MIL-E-23001/3D(AS)  
AMENDMENT 1  
25 March 1977

MILITARY SPECIFICATION SHEET

ELECTRIC GENERATING SYSTEM, AIRCRAFT, VSCF  
20 KVA, 115/200 VOLT, 3-PHASE, 400 Hz

This amendment forms a part of Military Specification Sheet MIL-E-23001/3D(AS), dated 25 July 1975.

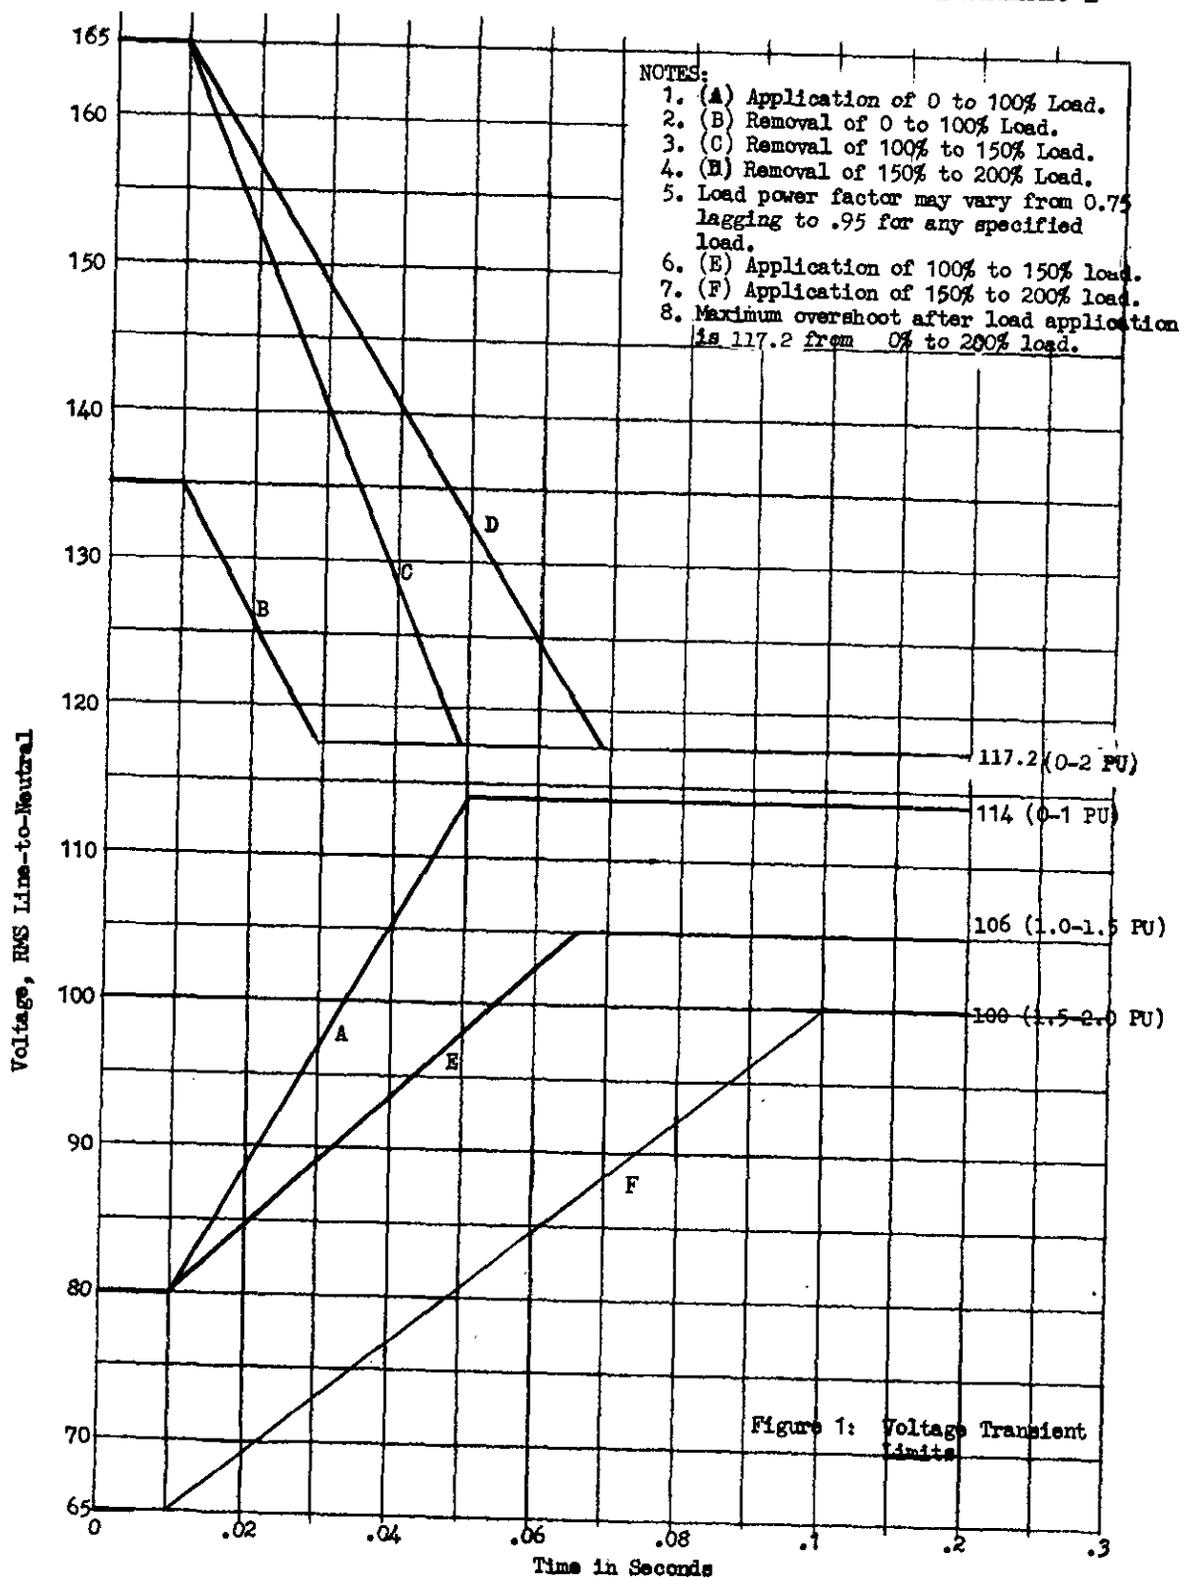
3.2.2 Add: "Curve F of Figure 1 of this amendment shall be modified to be zero volts from 0 to 2 seconds, after which time it goes directly to 100 volts."

Figure 1

Delete and substitute Figure 1 of this amendment.

Figure 5  
Filter Characteristic  
for measuring  
Voltage and Frequency  
Modulation

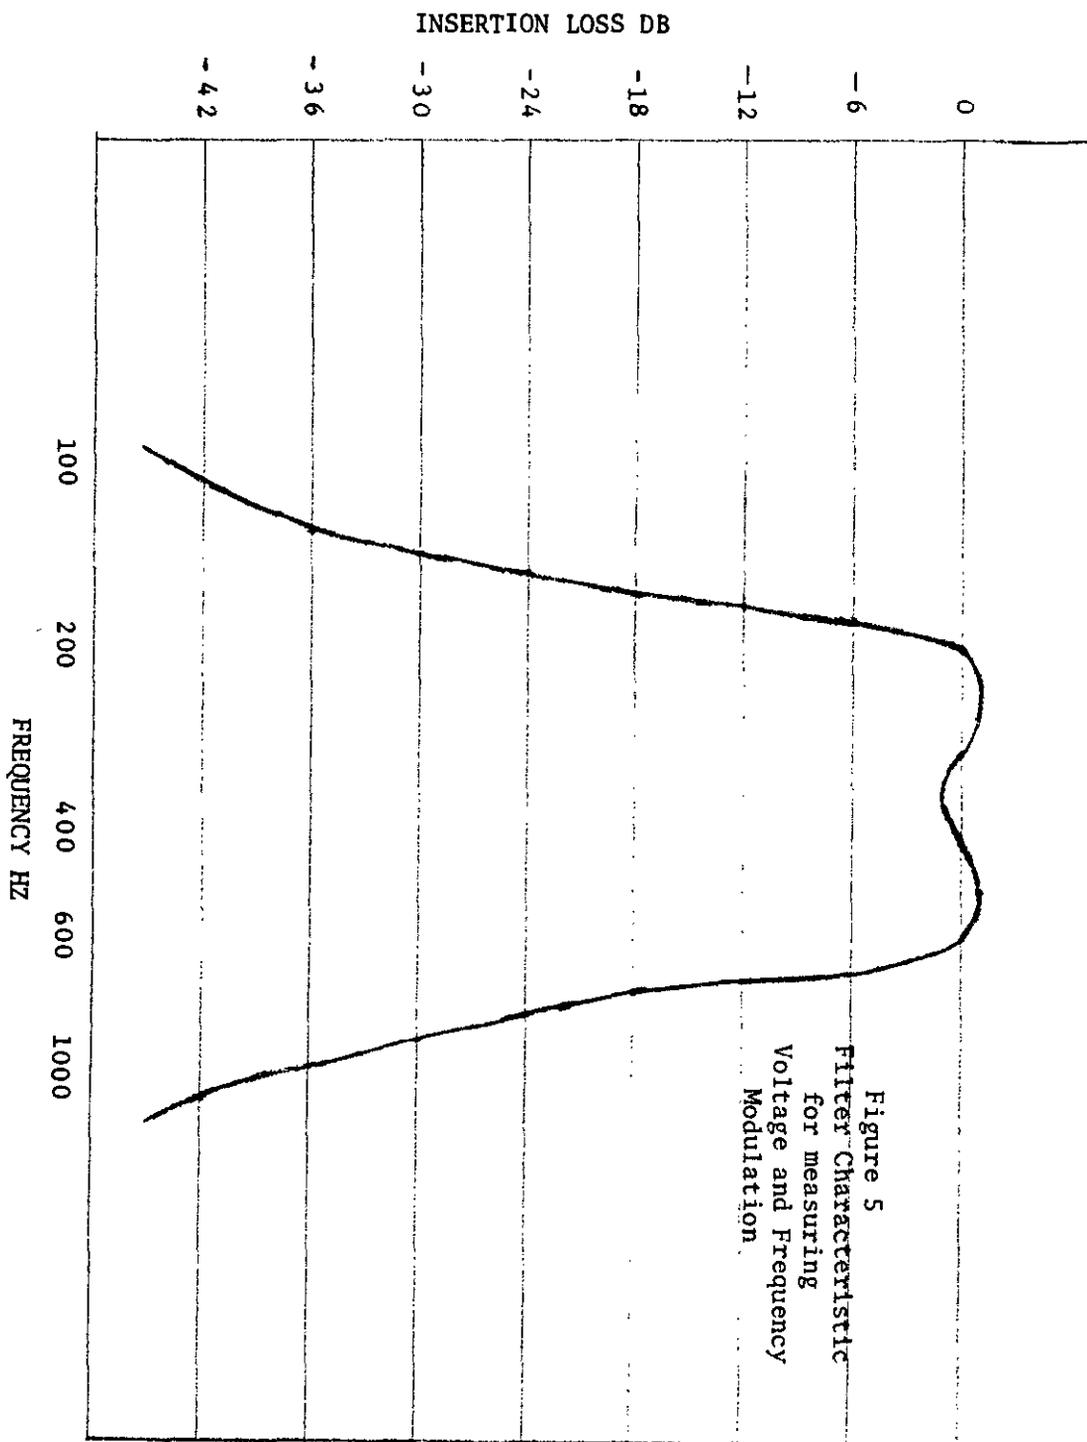
Add: 4.5.9 Voltage Modulation, Frequency Modulation, and Waveform. Delete "low-pass" and substitute "band-pass" in second sentence. Delete Figure 5 and substitute Figure 5 of this amendment.

Add 6.2.9 True Voltage Modulation. Delete "low-pass filter having a cut off frequency of 600 Hz" substitute "band pass filter having an insertion loss of less than one (1) db between 200 and 600 Hz."

Add: 6.2.11 True Frequency Modulation. Delete: "low-pass filter having a cut off frequency of 600 Hz" substitute "band pass filter having an insertion loss of less than one (1) db between 200 and 600 Hz."
